### APPEAL SUMMARY

<b>Appeal ID:</b> 18962	<b>Project Address:</b> 631 SE Taylor St
<b>Hearing Date:</b> 2/6/19	<b>Appellant Name:</b> Kathy Johnson
<b>Case No.:</b> B-015	<b>Appellant Phone:</b> 503.477.9165
<b>Appeal Type:</b> Building	<b>Plans Examiner/Inspector:</b> Steven Mortensen, Ed Marihart
<b>Project Type:</b> commercial	<b>Stories:</b> 3 <b>Occupancy:</b> R-2, B <b>Construction Type:</b> V-B
<b>Building/Business Name:</b> The Rose Apartments	<b>Fire Sprinklers:</b> Yes - Proposed throughout
<b>Appeal Involves:</b> Alteration of an existing structure	<b>LUR or Permit Application No.:</b>
<b>Plan Submitted Option:</b> pdf [File 1]	<b>Proposed use:</b> Existing R-2 and B to remain

PROJECT DESCRIPTION	
PROJECT NAME: THE ROSE APARTMENTS	PROJECT ADDRESS: 631 SE TAYLOR STREET, PORTLAND, OREGON
ORIGINAL CONSTRUCTION: 1910

LIFE SAFETY PLANS -  
APPEAL

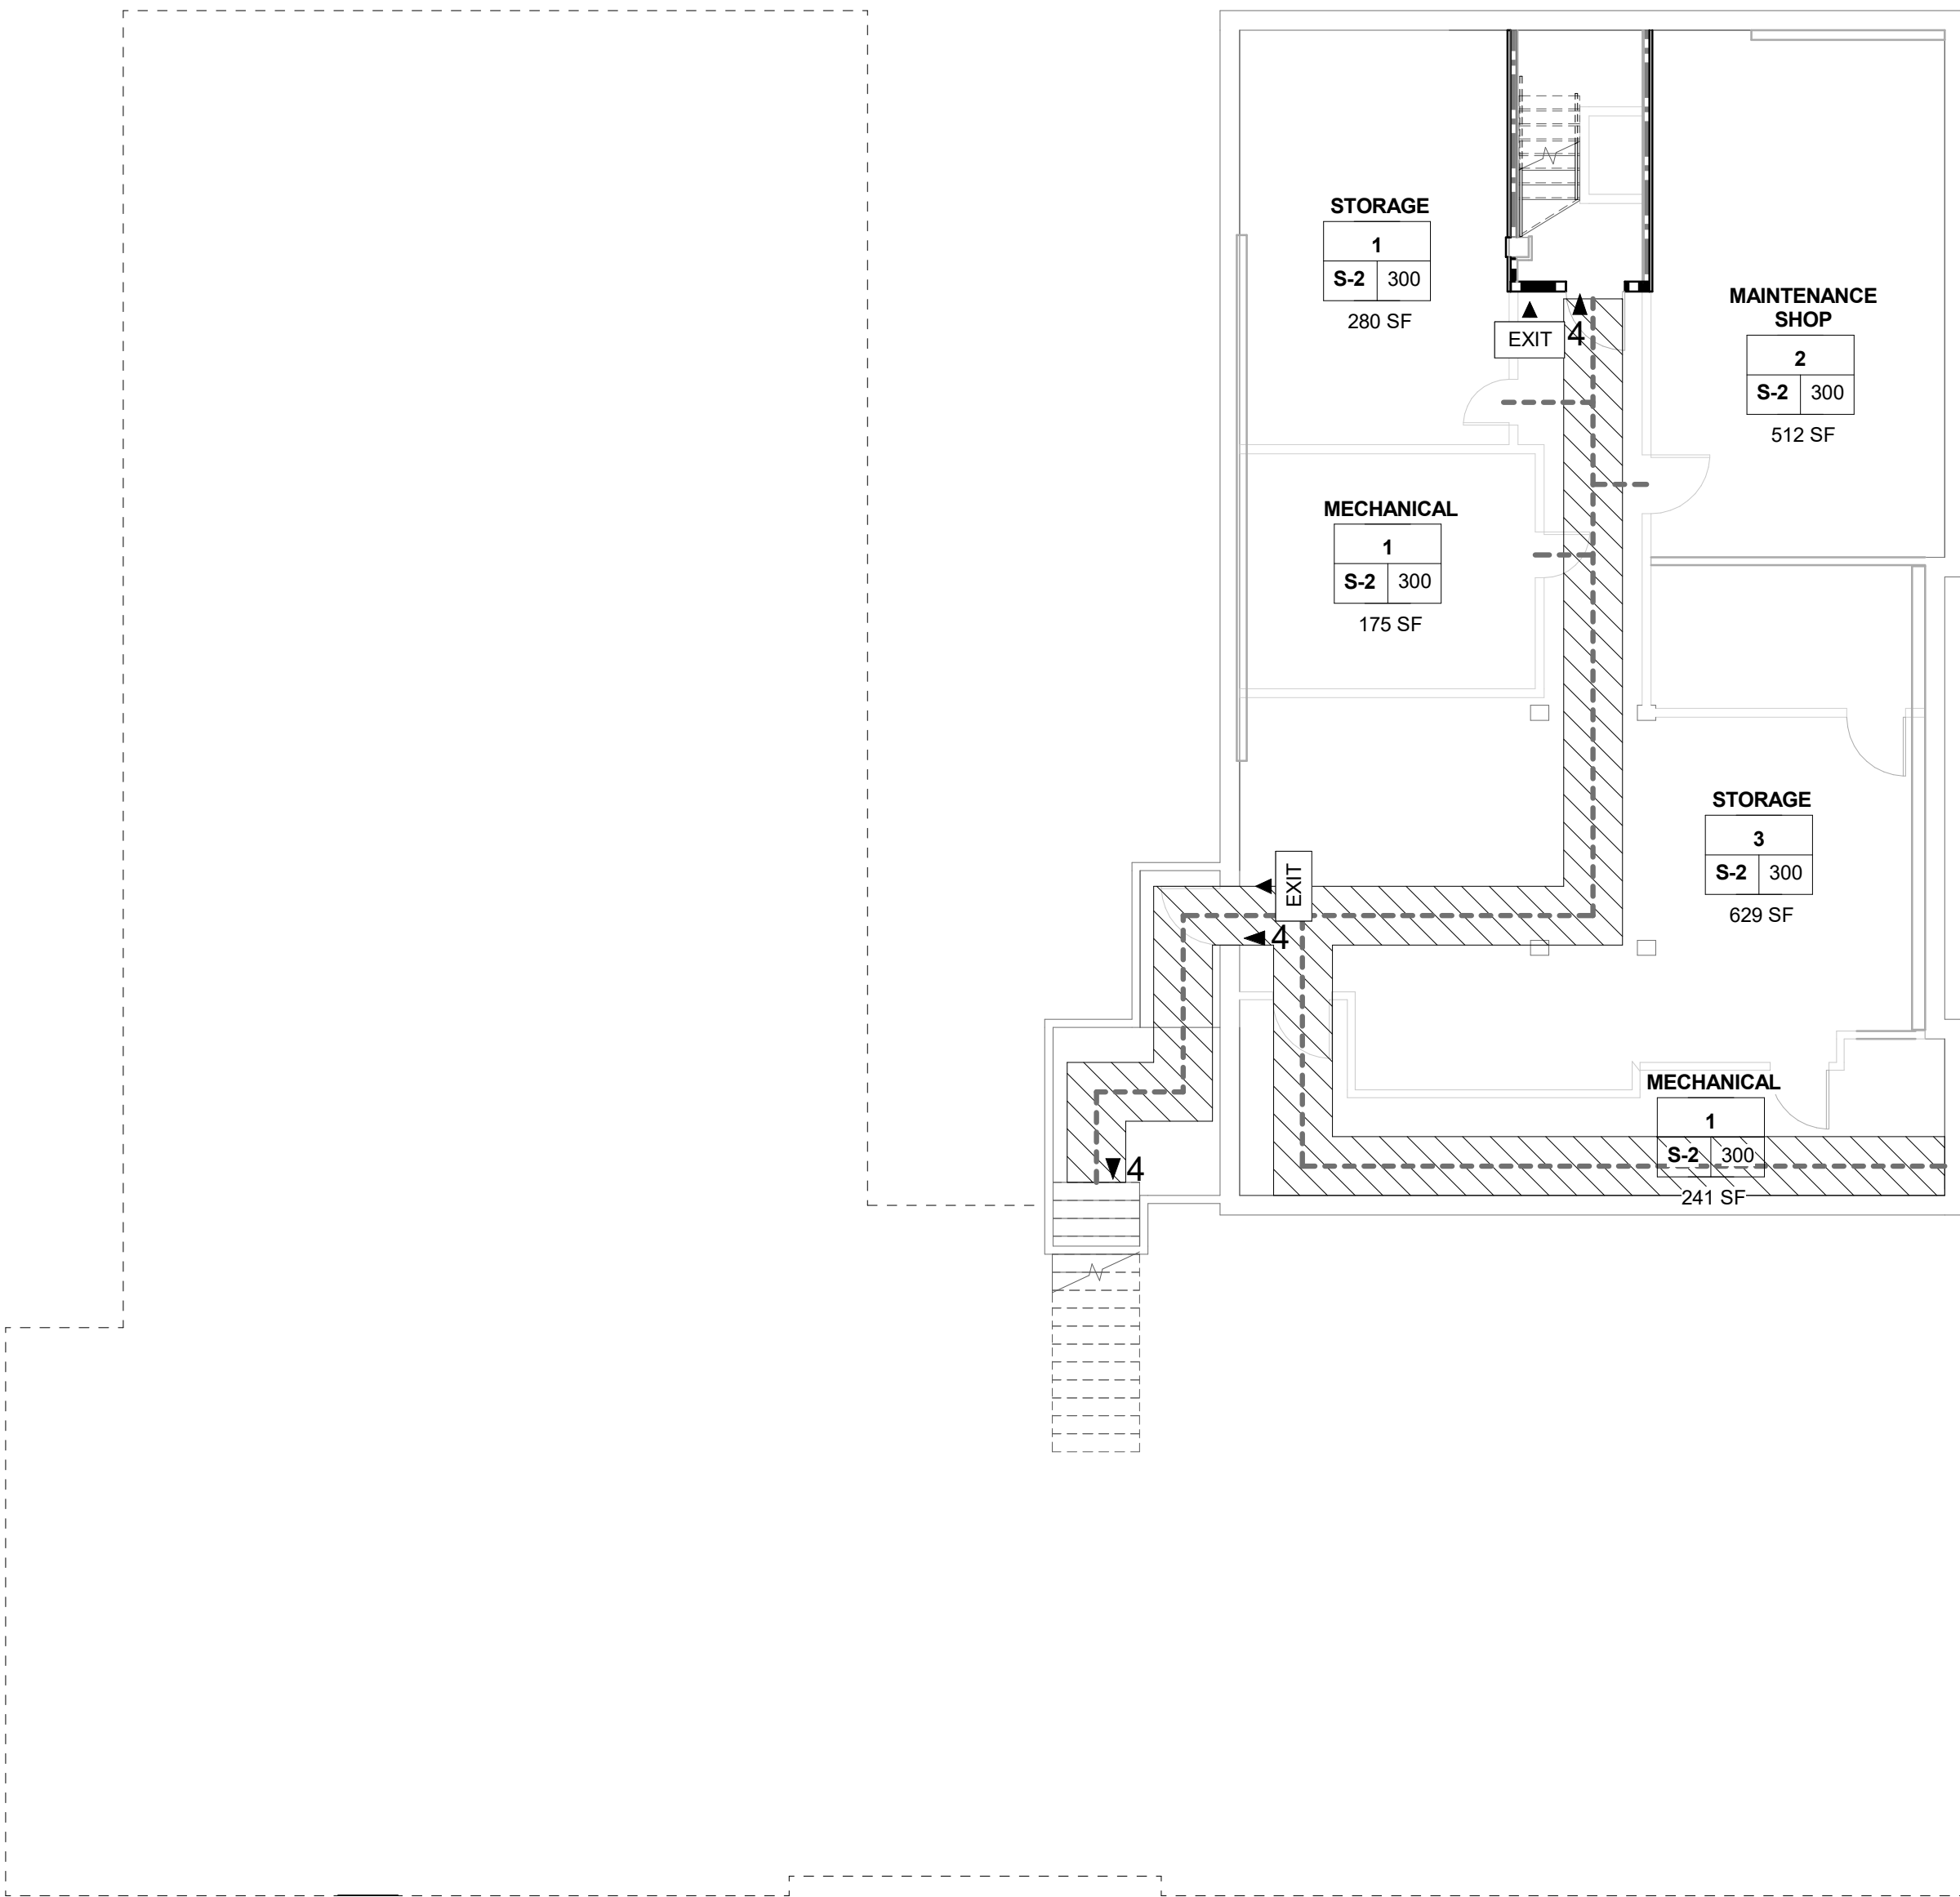
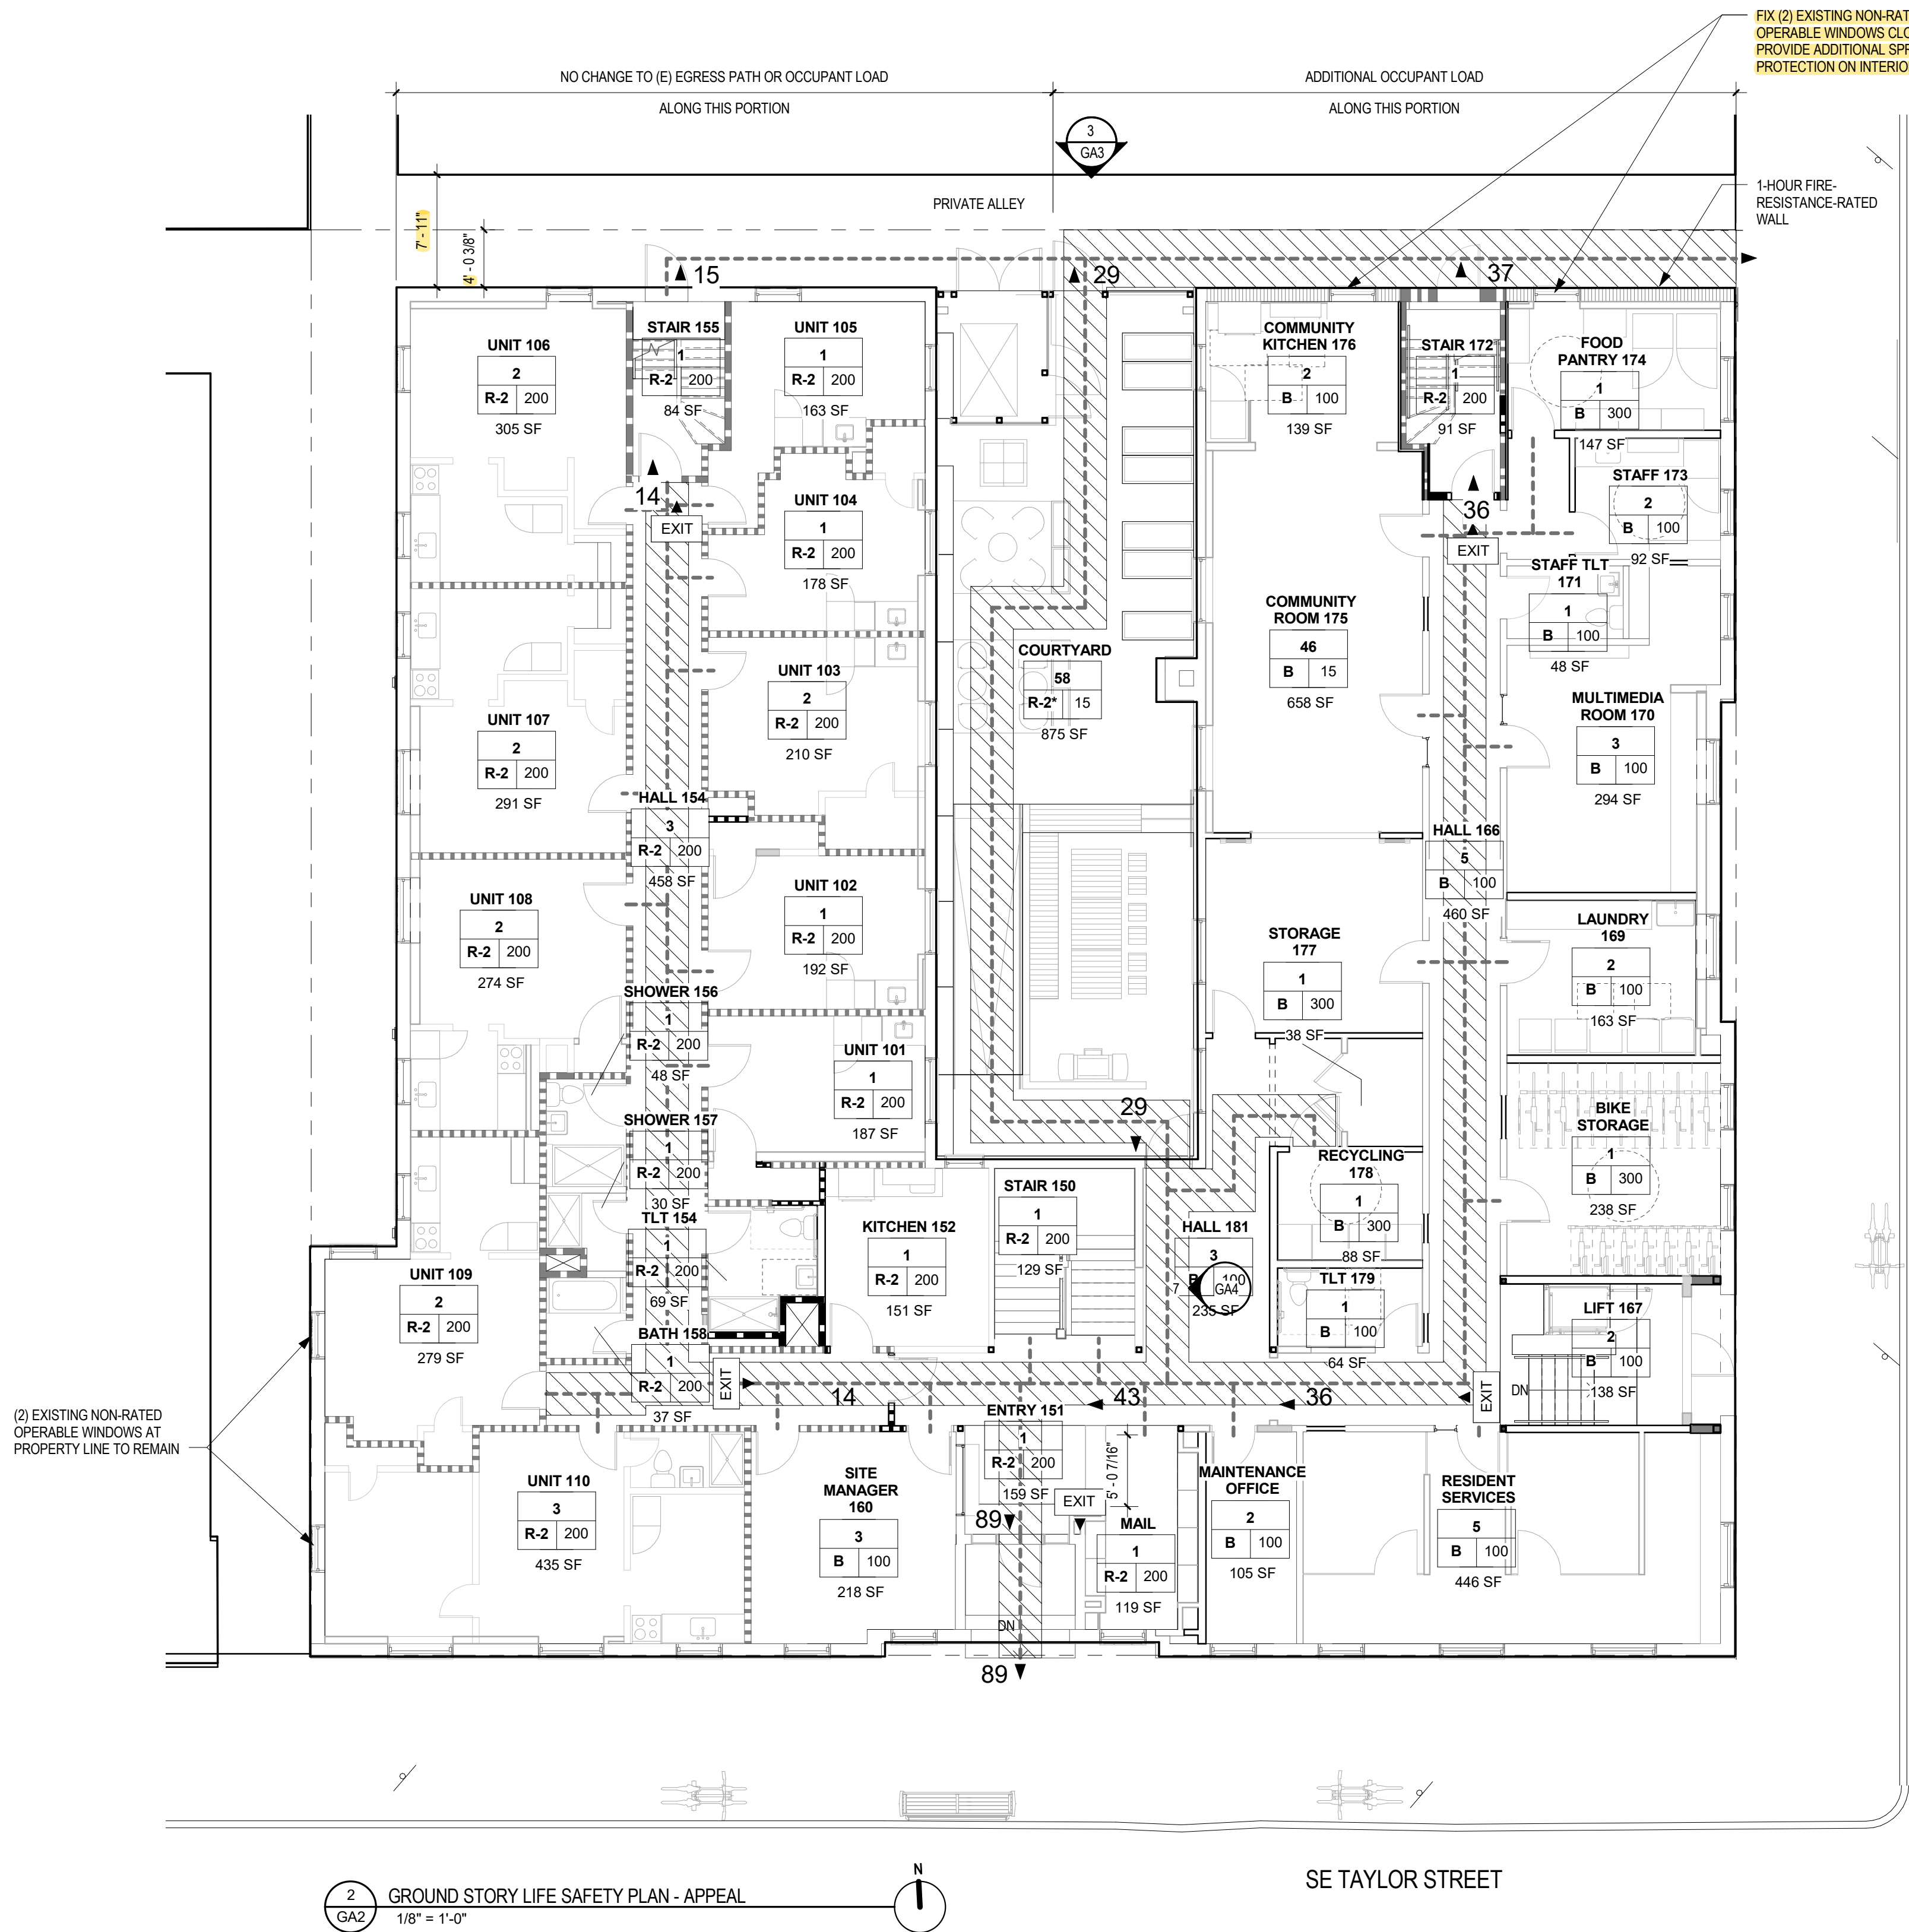
**Proposed Design** The existing northeast stair exits to a private alley that leads to the public way. As part of the remodeling of the ground story administrative/common use spaces and exterior courtyard, 33 additional occupants will be egressing through the alley. The alley is 8 feet wide overall; 4 feet of this is on this project site. The north wall of the building is constructed of two wyths (+/-8") of brick and achieves the required 1-hour fire-resistance-rated construction per Table 721.1(2). The northeast exit stair door will be replaced with a 90-minute door as part of repairing that stair's required two-hour enclosure. The two existing ground story non-rated operable windows adjacent to the egress court (approved by Appeal #6358) will be fixed in place with additional sprinkler protection on the interior side. See Sheet GA2.

**Reason for alternative** The existing north alley has always connected the exits on the north side of the building to the public way. As part of remodeling the ground story administrative and common use spaces, 4 additional occupants are being added to the northeast exit stair/door. Additionally, by permitting the existing exterior courtyard to formalize its use as outdoor space for the residents, 29 additional occupants are exiting through the alley.

The two existing non-rated operable windows adjacent to the egress court were permitted in 2009 and approved by Appeal #6358. Since the scope of this project does not include any window replacement, these windows will remain and be fixed in place to minimize the ability of fire to enter the egress court through the openings. Additional sprinkler protection will be added on the interior side of the windows to further mitigate their unrated condition.

- 1. Removal of building from Chapter 13 status: Hold for additional information.**
  - 2. Sprink protection of windows in egress court: Hold for additional information.**
  - 3. Winder treads in 2 egress stairs: Hold for additional information.**
  - 4. Omission of handrail extensions in 2 egress stairs: Hold for additional information.**
  - 5. Unprotected windows at property line: Hold for additional information.**
  - 6. Unprotected operable windows in exterior wall of 2 Exit stair enclosures: Denied. Proposal does not provide equivalent Life Safety protection.**
  - 7. Unclosed exit access stair: Hold for additional information.**
- Appellant may contact John Butler (503 823-7339) with questions.**
